DEPARTMENT OF PUBLIC WORKS

**MARINA DEL REY
COORDINATED INTEGRATED MONITORING PROGRAM
REQUEST FOR REVISION**

Exhibit A
Marina del Rey Coordinated Integrated Monitoring Program
Proposed Revisions

Figure 1 – Relocation of MdRU-C-1 to MdRU-C-1P11

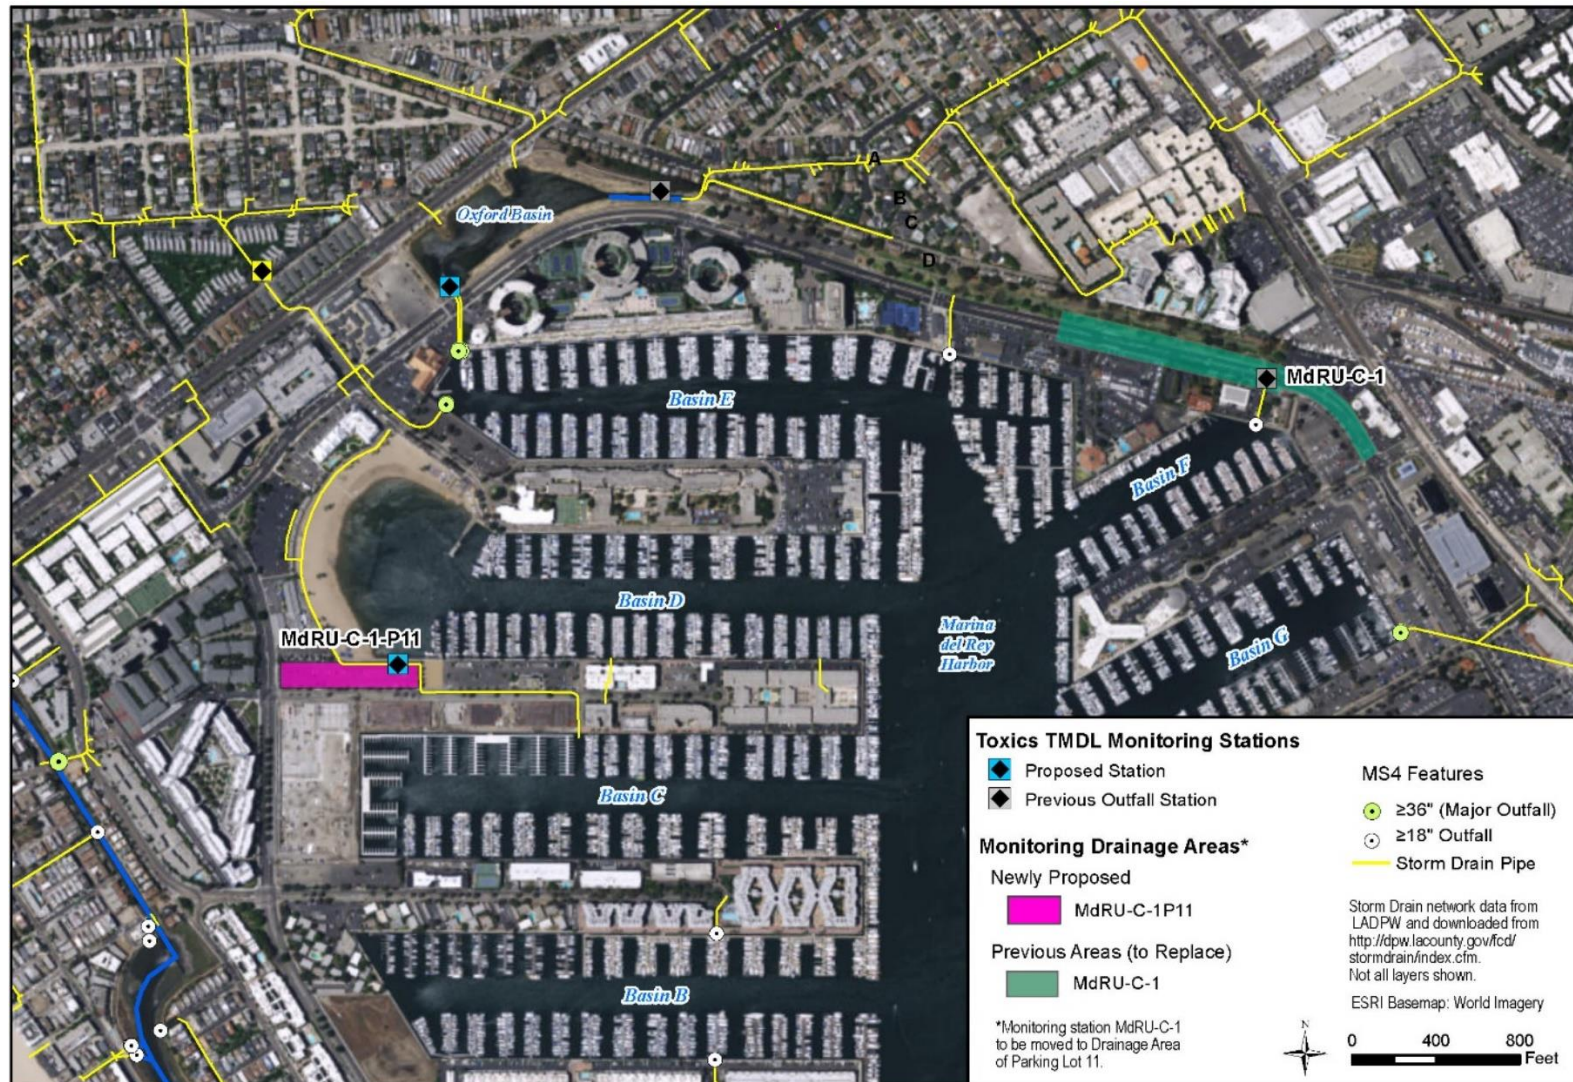
Relocation of MdRU-C-1 to MdRU-C-1P11 (Parking Lot 11)

A tabletop GIS evaluation was conducted on the top land uses (LUs) and percentages in the Marina del Rey Harbor to determine the new monitoring site. The top 4 LUs are Residential, Parking Lots, Commercial Services, and Transportation. Since parking lots is the 2nd highest land use within the Marina del Rey Harbor area, it is an appropriate land use to select for the proposed monitoring station.

All County parking lots around Marina del Rey Harbor area were evaluated based on available drainage infrastructure, drainage area, and accessibility. Parking Lot 11 was chosen as the most ideal location based on drainage area, parking lot usage, and accessibility. The larger drainage area will facilitate the collection of 20 to 30 liters of stormwater needed to conduct the required analyses.

See Figure 1 for location map of Parking Lot 11 compared to MdRU-C-1.

1.b	<p>Outfall Station MdRU-C-1 (Toxics TMDL Monitoring) MdRU-C-1 located on Admiralty Way, being used to represent Commercial land use</p>	<p>Outfall Station MdRU-C-1P11 (Toxics TMDL Monitoring) MdRU-C-1P11 located at Parking Lot 11</p>	<p>1. MdRU-C-1 drains Admiralty Way, which is not representative of Commercial land use (mainly secondary roads land use).</p> <p>2. Evaluation of land use and available parking lots in the underrepresented Marina del Rey area revealed that parking lots make up a higher land use percentage than Commercial land use.</p> <p>3. Proposed MdRU-C-1P11 will be representative of the Commercial and Parking Lot land uses in the underrepresented Marina del Rey area.</p>

Figure 2 – Relocation of MdR-3 and MdR-4 to MdR-4ORB

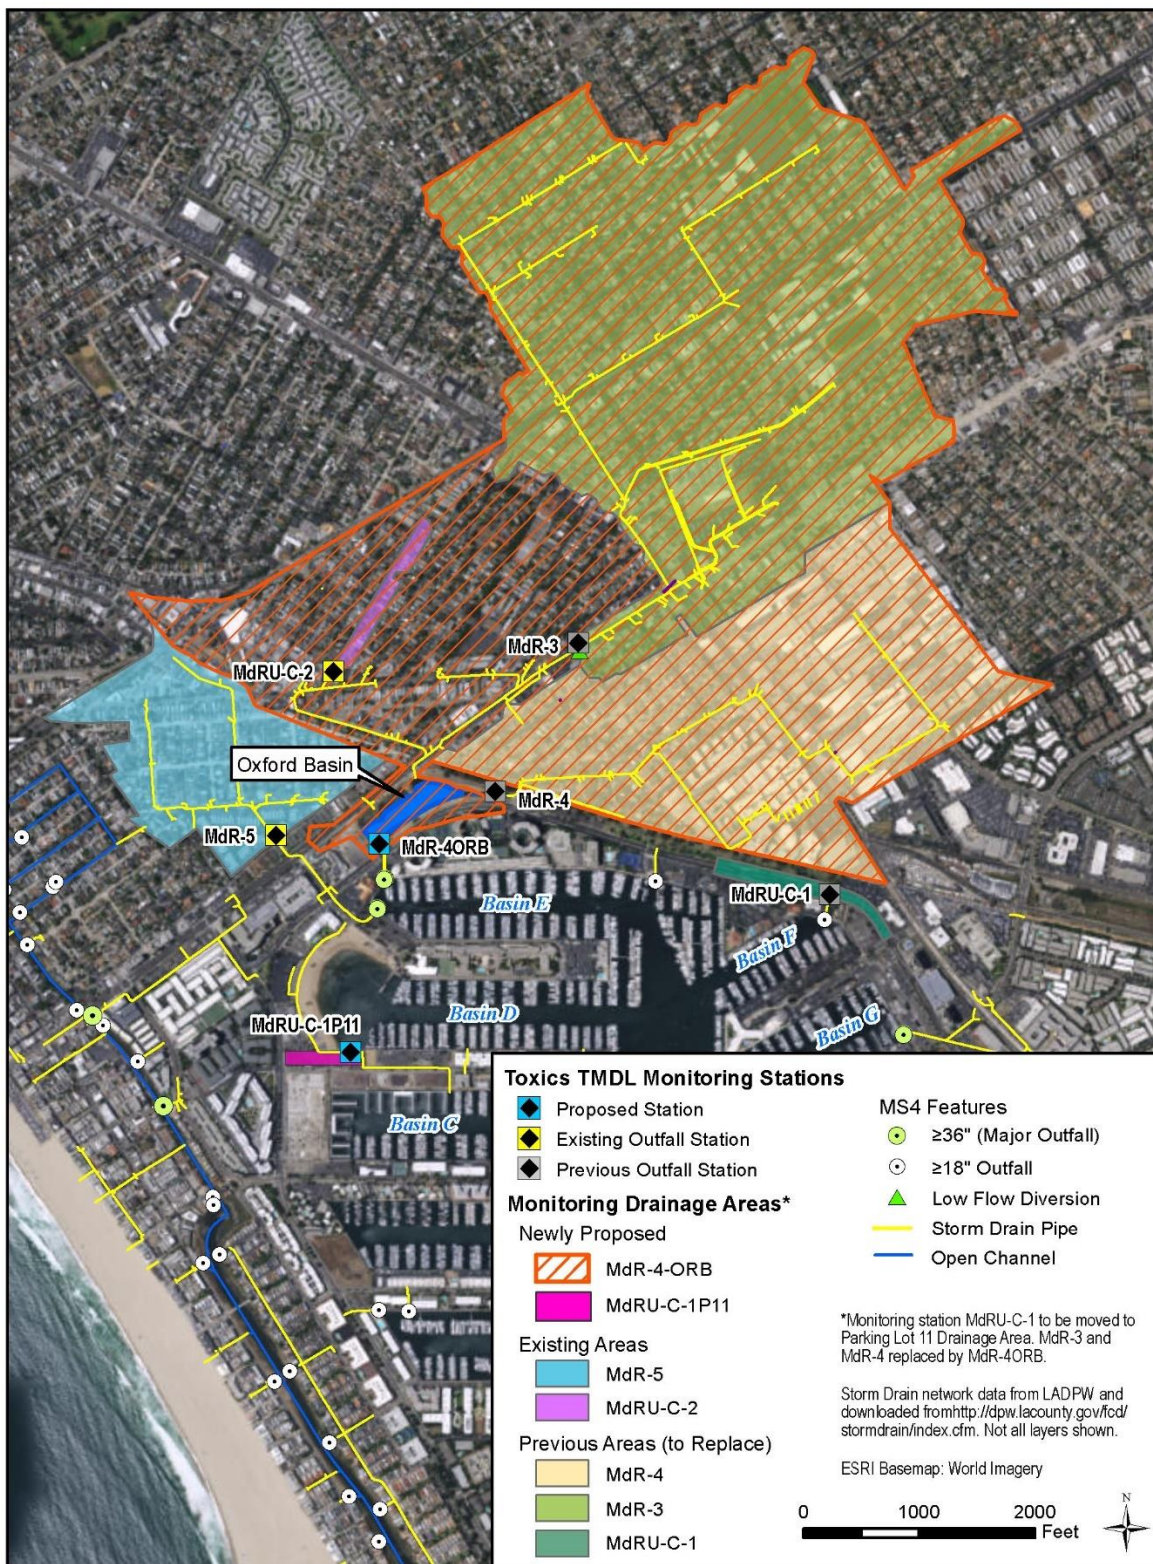
Relocation of MdR-3 and MdR-4 to MdR-4-ORB

With the relocation of MdR-3 and MdR-4 to MdR-4-ORB, MdR-3 will be removed, and Permit Monitoring will be shifted to MdR-5. This table shows the Land Use for MdR-3 before and after excluding the areas addressed by the proposed Washington Blvd project, in comparison with MdR-5.

Figure 2 shows the locations of the existing and proposed monitoring location along with the drainage area for each monitoring location.

#	Current	Proposed Revision	Justification
1	Outfall Monitoring Locations		
1.a	<p>Outfall Station MdR-3 - Permit and Toxics TMDL Monitoring MdR-3 on Washington Blvd.</p> <p>Outfall Station MdR-4 - Toxics TMDL Monitoring upstream of Oxford Retention Basin</p>	<p>Outfall Station MdR-4-ORB - Toxics TMDL Monitoring MdR-4-ORB in Oxford Retention Basin (ORB)</p> <p>Stormwater samples will be taken in ORB near the tide gates prior to discharge into Basin E of the Marina del Rey Harbor.</p>	<p>1. MdR-3 and MdR-4 both drain into ORB.</p> <p>2. MdR-3 and MdR-4 currently drain approximately 343 & 172 acres, respectively, for a total of 515 acres. MdR-ORB will represent approximately 667 acres of drainage area. Direct measurement and calculation of pollutants from a larger drainage will provide a more accurate pollutant loading.</p> <p>3. Samples taken in ORB near the tide gates would be more representative of what will be discharged from the watershed during a storm event.</p> <p>4. Monitoring at MdR-3 will be impacted by the upcoming Washington Blvd Project while monitoring MdR-4 has been impacted by the recently constructed ORB project.</p>

1.c	<p>MdR-3 is the representative Permit Outfall Monitoring Station.</p>	<p>MdR-5 is the representative Permit Outfall Monitoring Station.</p>	<p>1. MdR-3 will be removed and replaced by MdR-4-ORB</p> <p>2. MdR-3 and MdR-5 drainage areas have a similar land use composition</p> <p>3. MdR-5 is not impacted by tidal influence</p>
